# PRINCE OF WALES ISLAND, ALASKA POW HYDABURG HIGHWAY FISH PASSAGE IMPROVEMENTS

# PROJECT No. 68026 / FS #07RO-11100100-076

AS-BUILT PLANS

**BAFFLE DETAIL**

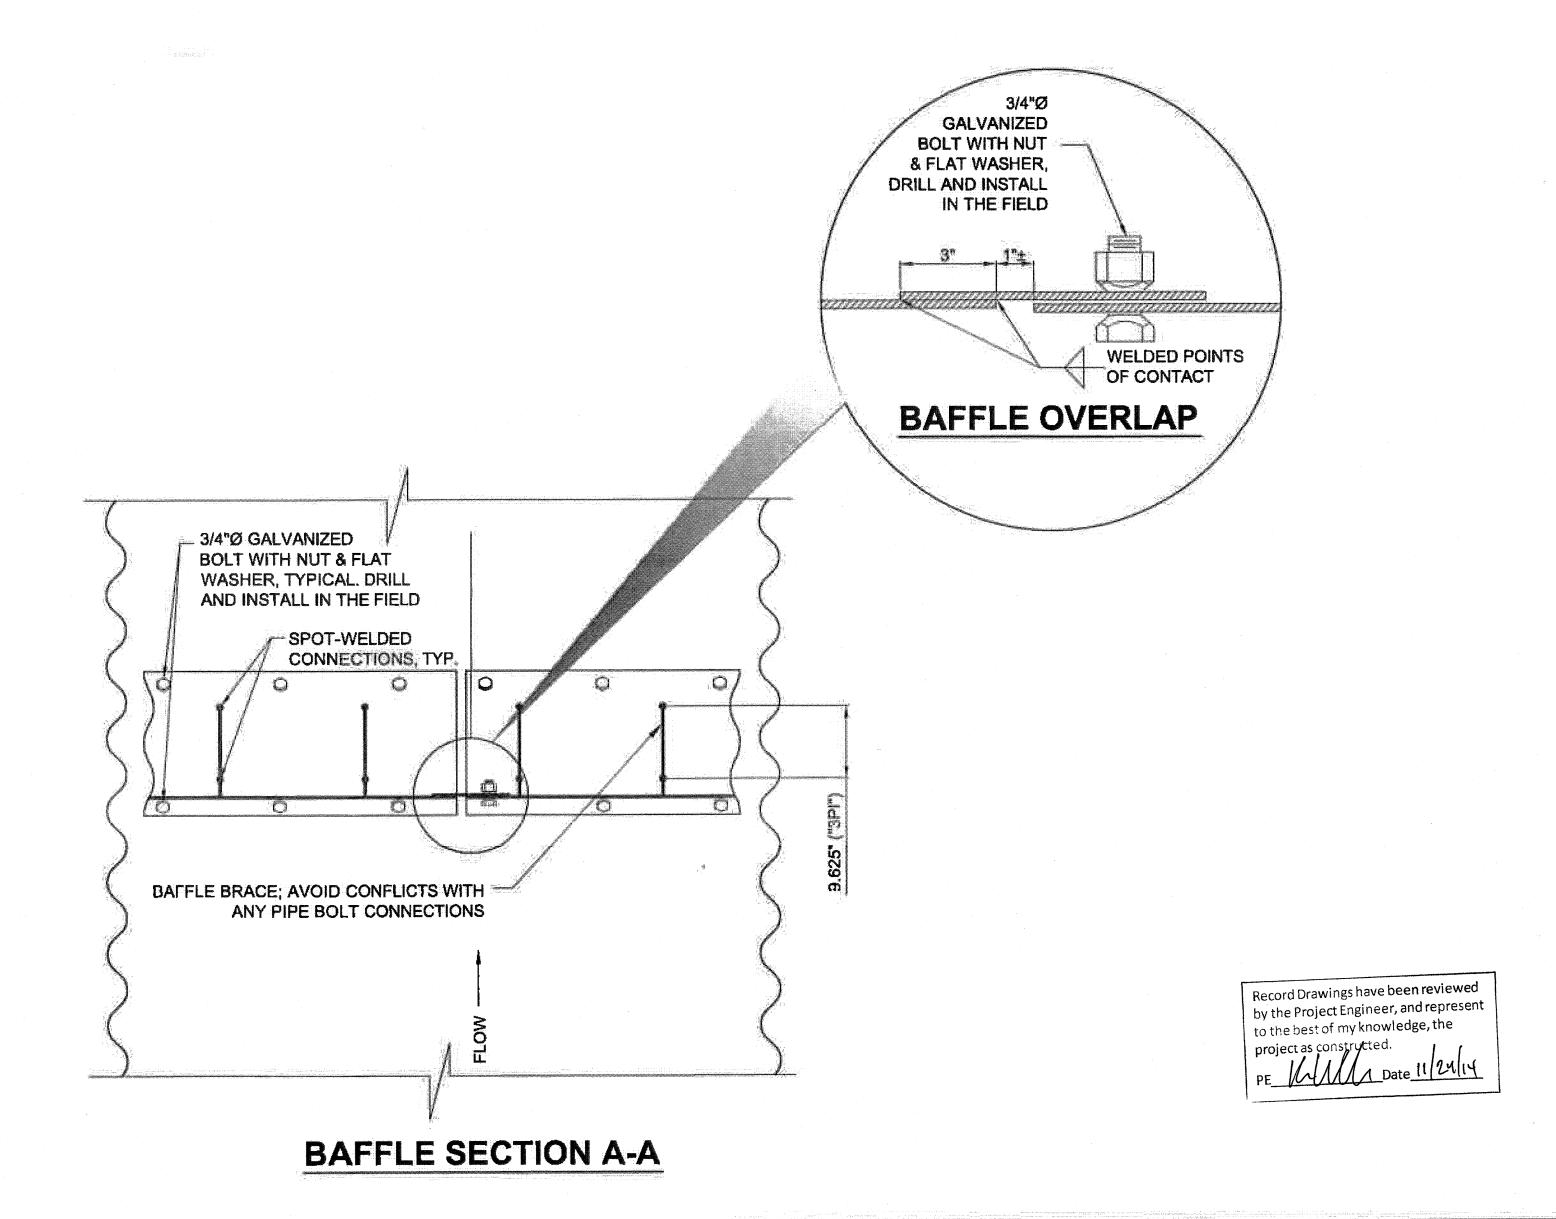
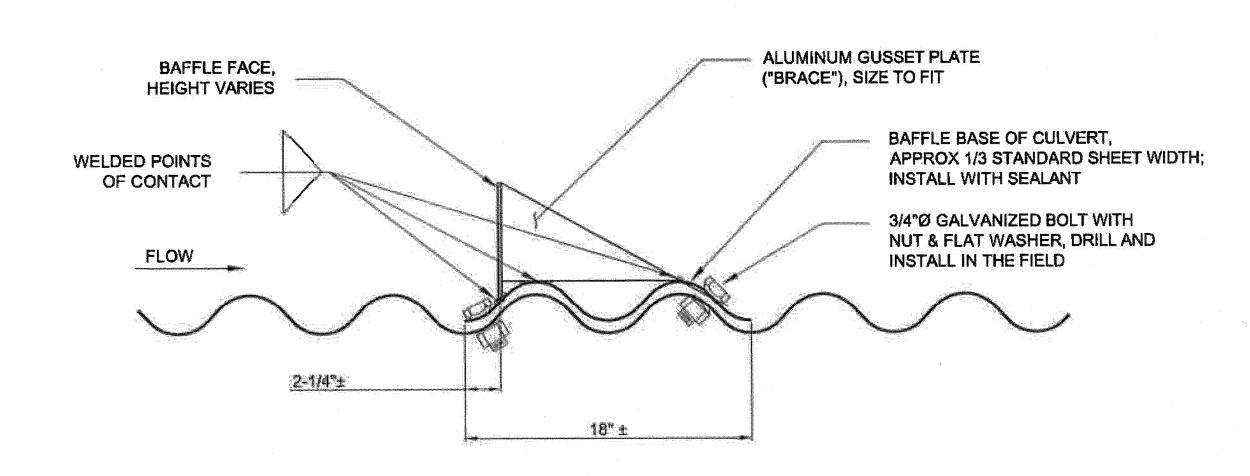
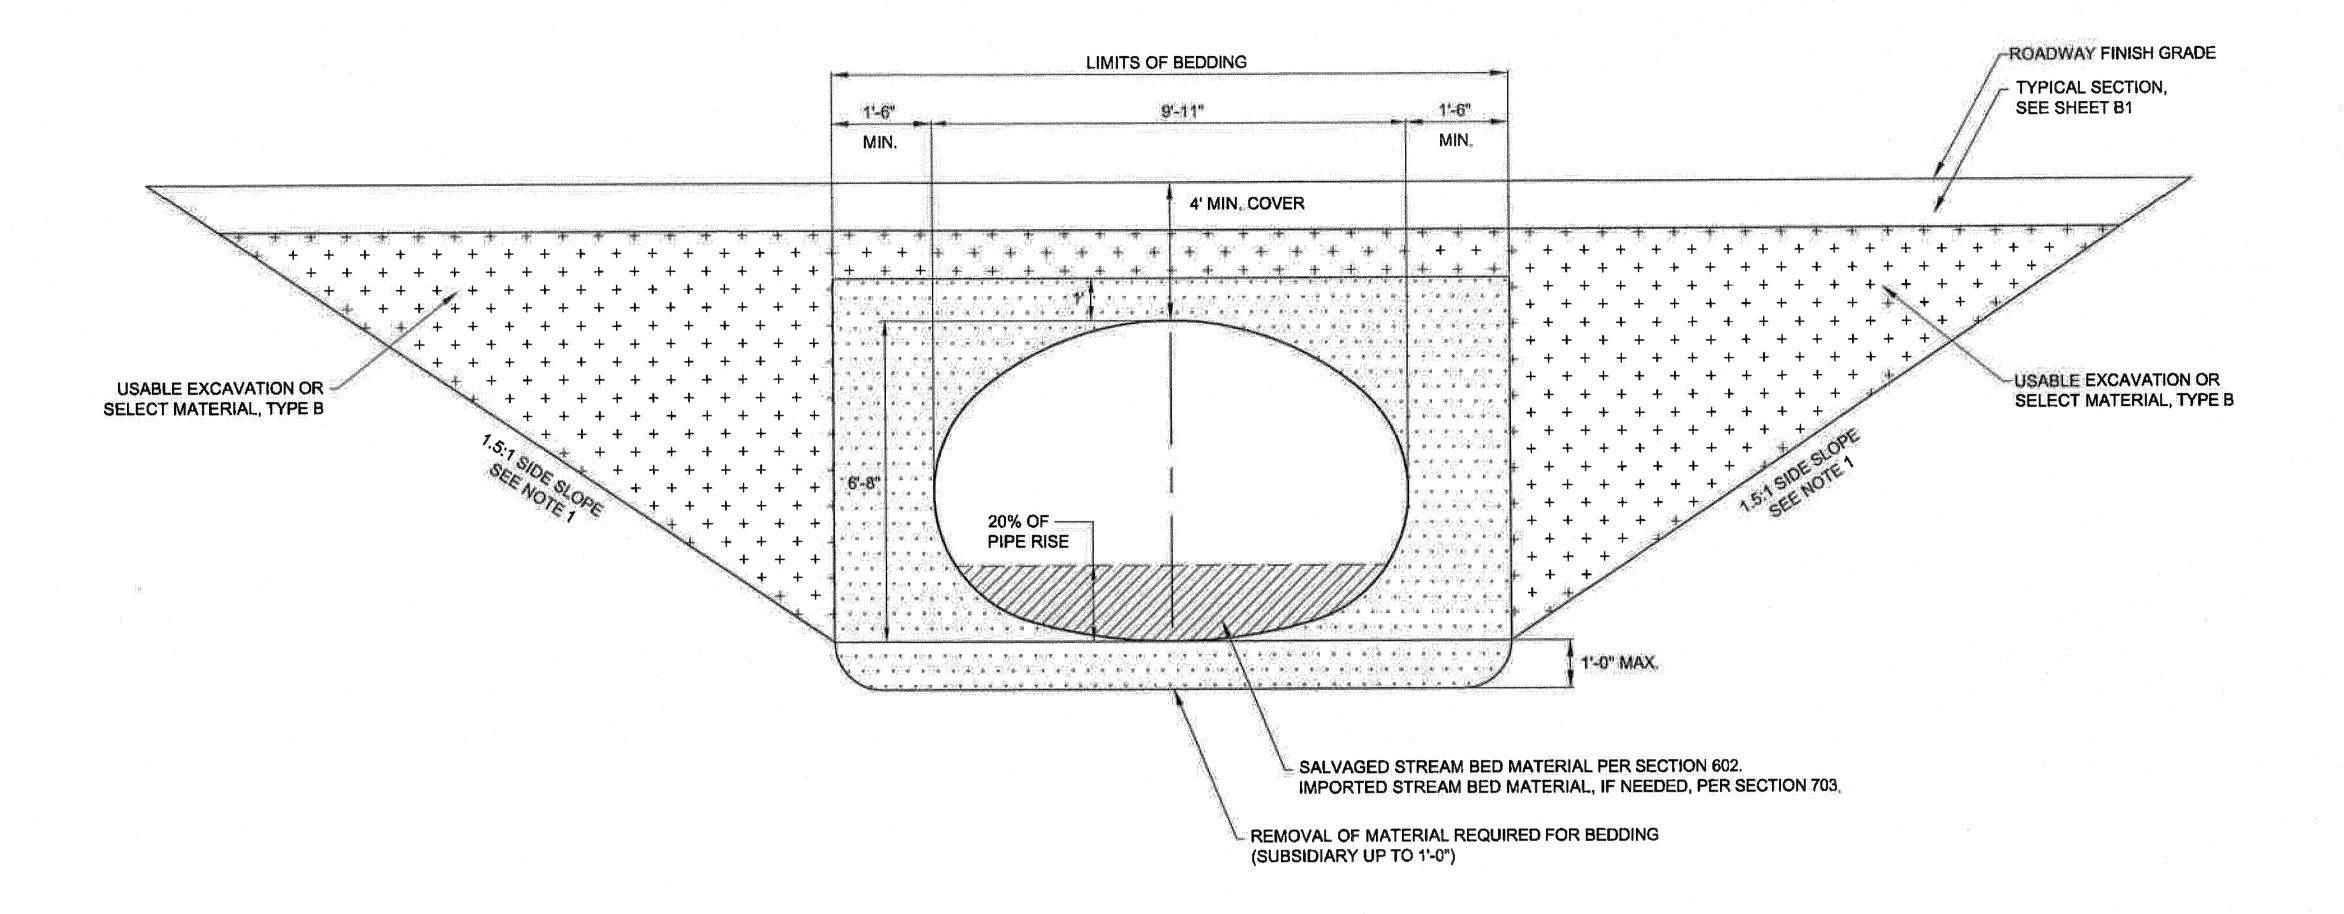
BA	FFLE TA	ABLE	
STA	DESCRIPTION	CL ELEV	
4+00	Culvert Invert	<del>176.8</del>	176.41
4+01	Baffle #1	178.1	
4+10	Baffle #2	177.8	
4+20	Baffle #3	177.5	
4+30	Baffle #4	177.3	
4+40	Baffle #5	177.0	
4+50	Baffle #6	176.8	
4+60	Baffle #7	176.5	
4+70	Baffle #8	176.2	
4+80	Baffle #9	176.0	
4+90	Baffle #10	175.7	
5+00	Baffle #11	175.4	
5+10	Baffle #12	175.2	
5+20	Baffle #13	174.9	
5+30	Baffle #14	174.7	
5+39	Baffle #15	174.4	
5+40	Culvert Invert	473.4	172.39
